JOHN ROGERS ELEMENTARY SCHOOL DESIGN DEPARTURE RECOMMENDATIONS

Project #3039302-SD

November 18, 2022

Requested Departure #1: Building Height

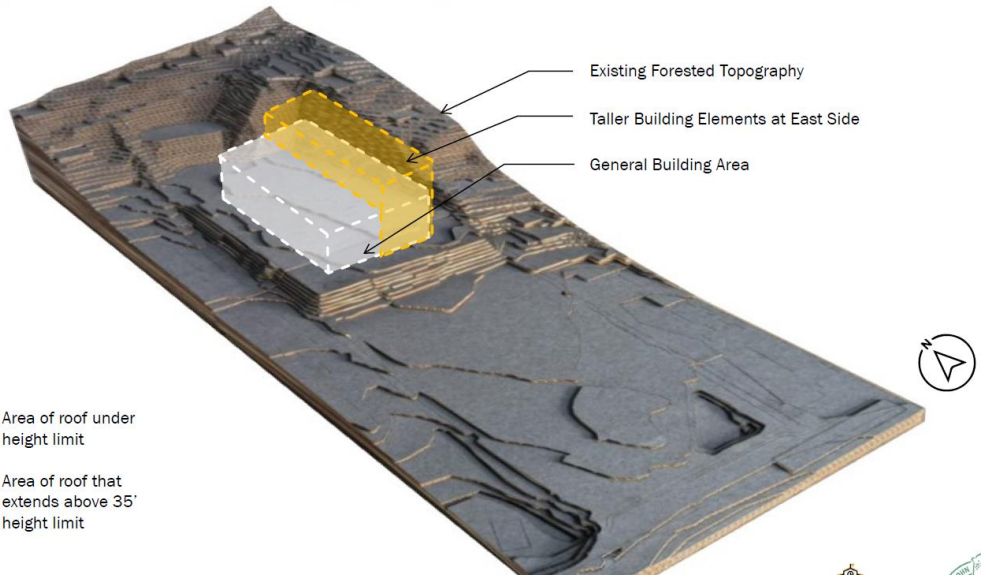
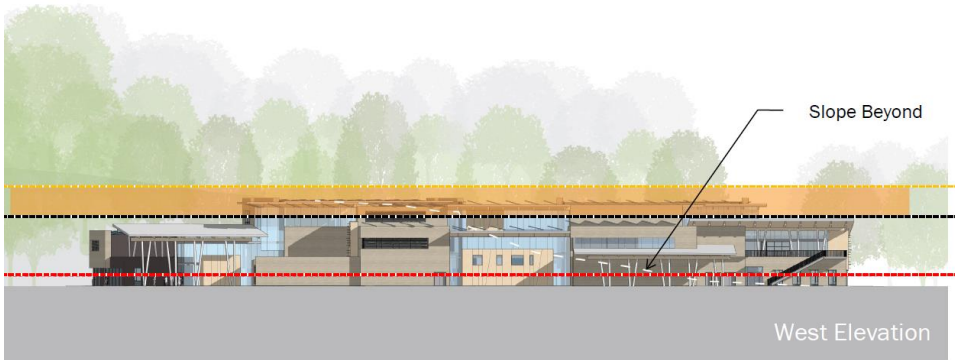
There were few comments related to the Departure seeking additional building height. However, one individual did indicate that the building would likely block out sunlight to her yard. It appears that the new building will cast shadow on the homeowner's house and side yard, though a large stand of trees will continue to provide shade and maintain visual separation from the homeowner's backyard. As described earlier in this letter and outlined in the Departures presentation, site constraints such as liquefiable soils, steep slopes and utility easements greatly reduces the buildable area of the site. To meet Seattle Public Schools teaching and learning program requirements, a 3-story structure became necessary. However, the 3-story wings are intentionally located along the eastern edge of the site, where they are largely adjacent to a steep slope hillside and tall trees. To help mitigate building height, large mechanical units are located within the western side of the building, on each of the three building levels, eliminating the need for mechanical penthouses on top of the 3-story structure and minimizing the requested Departure height. Further, the design implements lower canopy roof structures at the eastern side of the 3-story wings to help reduce scale and provide outdoor learning opportunities for students.

SPS and the Design Team noted in their departure's presentation and their response to public comments that property constraints such as liquefiable soils, steep slopes and utility easements reduce the buildable area of the site. To meet SPS' teaching and learning program requirements, a 3-story structure became necessary.

The Design Team also noted that the design implements lower canopy structures at the eastern side of the three-story wings to help reduce scale and provide outdoor learning opportunities for students.

Requested Departure #2 : Vehicular Parking Quantity

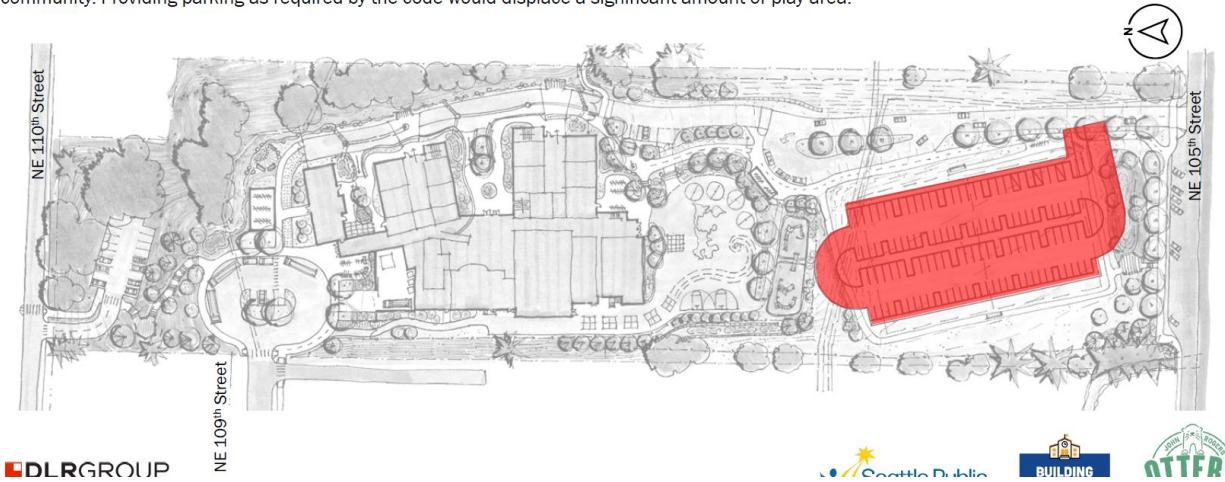
We oppose the proposal to provide only 39 parking spaces in the rebuild of John Rogers Elementary School. The code requires 145 vehicle parking spaces. The plan asks for an exemption (departure) of 106 spaces. 39 parking spaces is simply not enough parking at the school.

To balance the various site constraints and program requirements, the project team proposed striped parking stalls exceeding that which is currently provided at the school. As the team continued to refine the design, additional daily and event parking were added to what was shown in SPS' earlier presentation. These include:

There were several comments expressing concerns regarding the parking departure. The John Rogers Elementary School site is particularly constrained by liquefiable soils, steep slopes, utility easements and Seattle Public Schools program requirements for teaching, learning and indoor/outdoor play. To balance the various site constraints and program requirements, the project team has provided striped parking stalls exceeding that which is currently provided at John Rogers Elementary. As the design team has continued to refine the design, we have been able to add additional daily parking and event parking from what was shown in the Departures presentation. An additional three parking stalls have been provided for a total of 42 striped parking stalls (39 are indicated in the Departures slide deck). Further, the design now allows for overflow and event parking at the hard surface play providing an additional 20 parking stalls for a total of 32 evening and event parking stalls (12 are indicated in the Departures slide deck). All in all, 74 parking stalls are available for large events (51 are indicated in the Departures slide deck).

Requested Departure #4 : Changing Image Sign

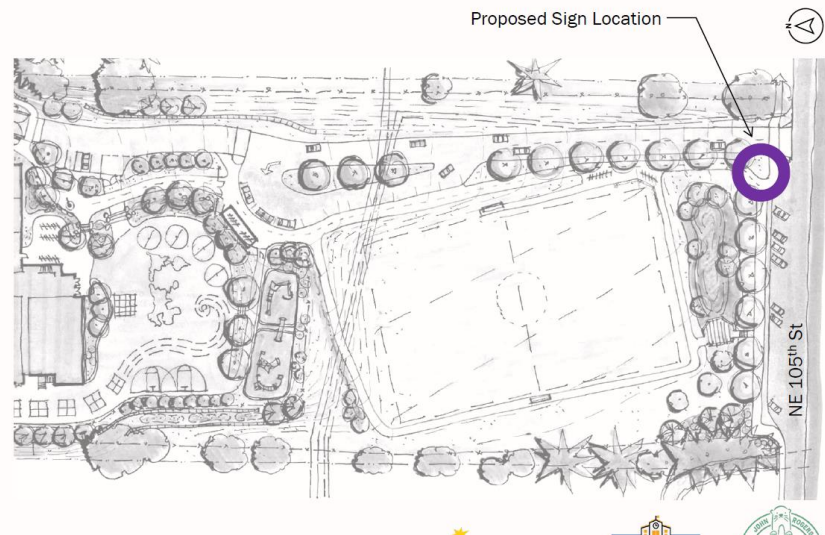
- C. Less than required secure long-term bicycle parking (19 spaces planned, City code requires 73);
 - D. An electronic changing-image reader board sign (not allowed by City code).
Bright electronic night-time signs are not consistent with residential neighborhoods, and many school neighborhoods have successfully rejected allowing such signs.

- 1) **The electric reader board may only be turned on between 7am to 9pm.**
- 2) **No video, flashing, scrolling, or moving images; however, messages can change to show content.**
- 3) **Sign illumination should be limited to one color with a dark background.**
